MFN 06-249

**Subject: Response to Portion of NRC Request for Additional Information
Letter No. 26 Related to ESBWR Design Certification Application –
Isolation Condenser – RAI Numbers 5.4-21, 5.4-23 through 5.4-26,
5.4-28 through 5.4-30, 5.4-32 through 5.4-35, 5.4-38, 5.4-41, 5.4-42,
5.4-44 through 5.4-46, 5.4-48, 5.4-50, and 5.4-52**

ENCLOSURE 1

Isolation Condenser

Appendix A

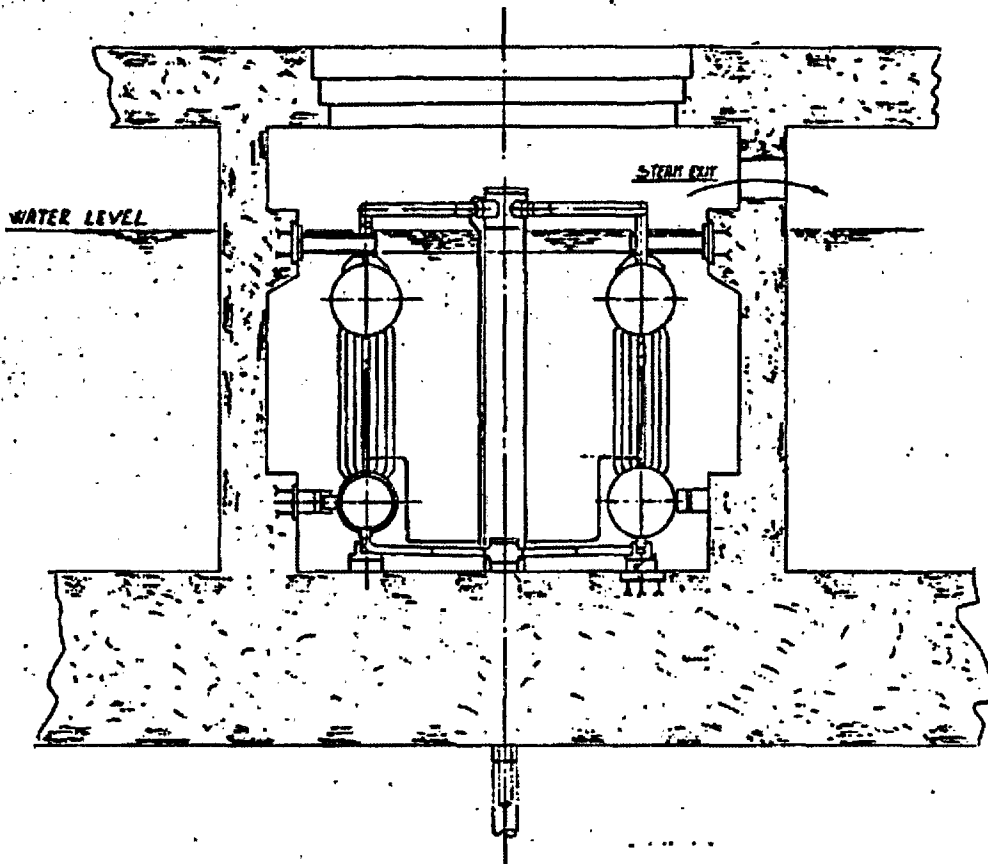
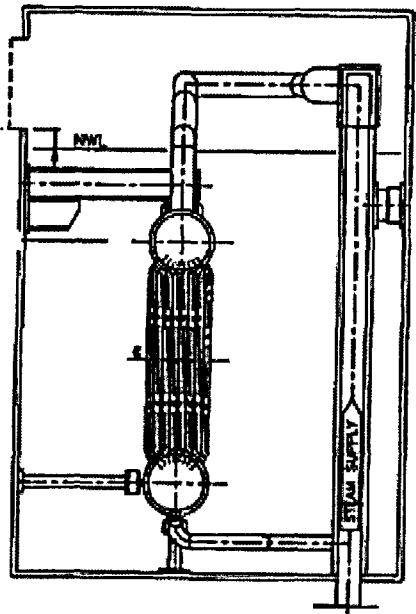
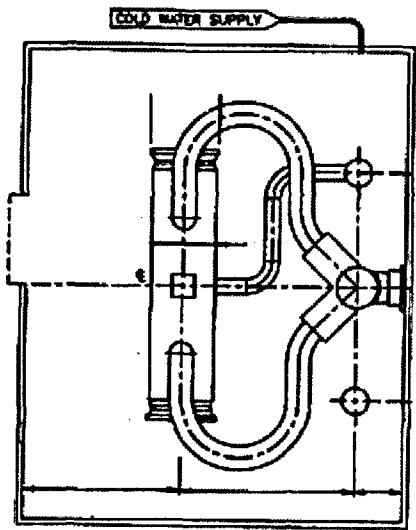
The isolation condenser (IC) for the ESBWR is a vertical heat exchanger significantly different from operating plants' ICs. Provide the following: a detailed description of the heat exchanger, the heat transfer coefficient required for this heat exchanger, and a drawing of the ESBWR IC in DCD Tier 2.

(C) Provide a Drawing of the ESBWR IC in DCD Tier 2

A schematic of the IC heat exchanger was provided to the NRC in the SEIT Panther ICS Test Report. In Appendix A of this letter is a copy of the schematic found in the Panther Test Report and an ANSALDO P&ID. A drawing of the IC will not be included in Tier 2 of the DCD.
